SERVICE LETTER – MOSTER185

Oil leakage from the exhaust joint

AM04-ATOM080-004-SL_00	
	Vittorazi Motors Via Marche 1 - 62010 Morrovalle (MC) - Italy Tel./Fax +39.0733.866595 Email: info@vittorazi.com

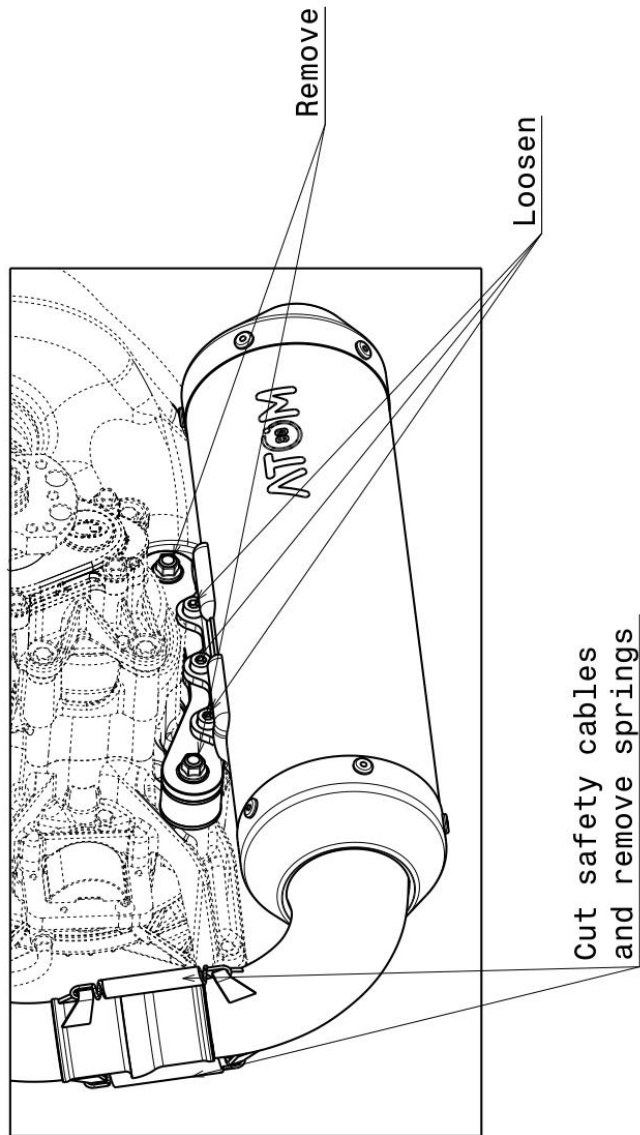
1. Remove joint springs
Remove M8 nuts
Loosen M6 screws

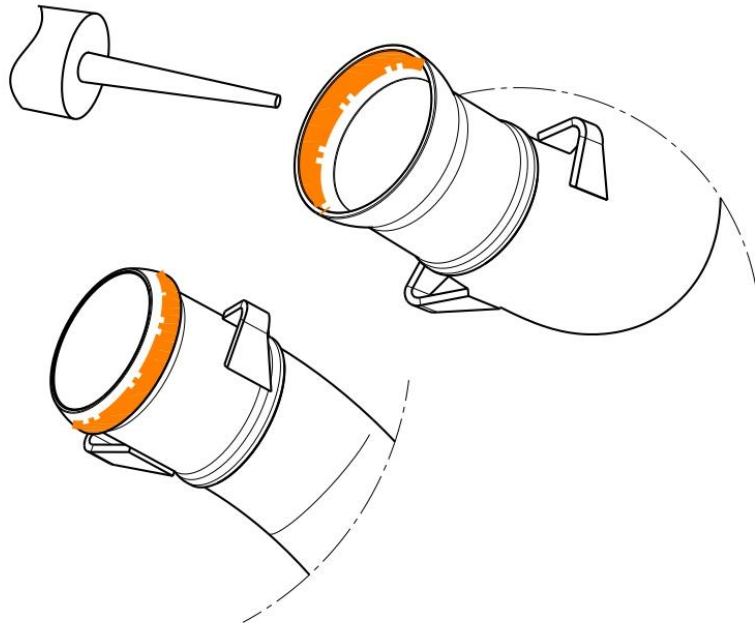
2. Apply a small quantity of high temperature silicone sealant.

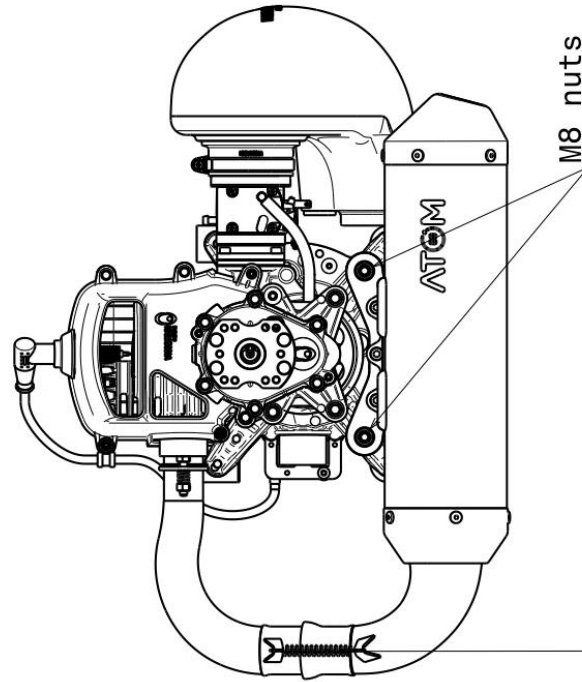
3. Place the exhaust on the engine: apply M8 nuts without tightening

Hook the springs and safety cables

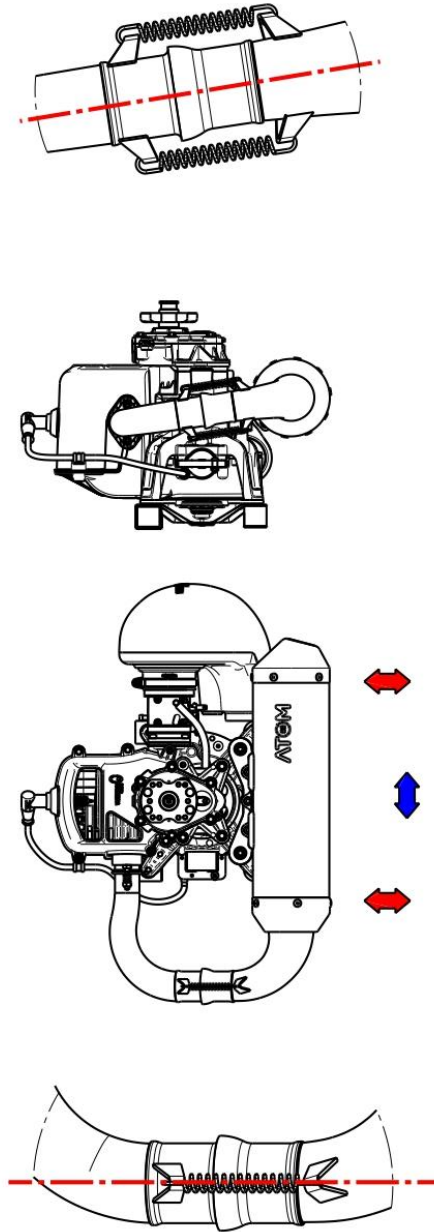
4. Check the correct alignment of the exhaust joint

5. When the joint is aligned, tighten screws and nuts
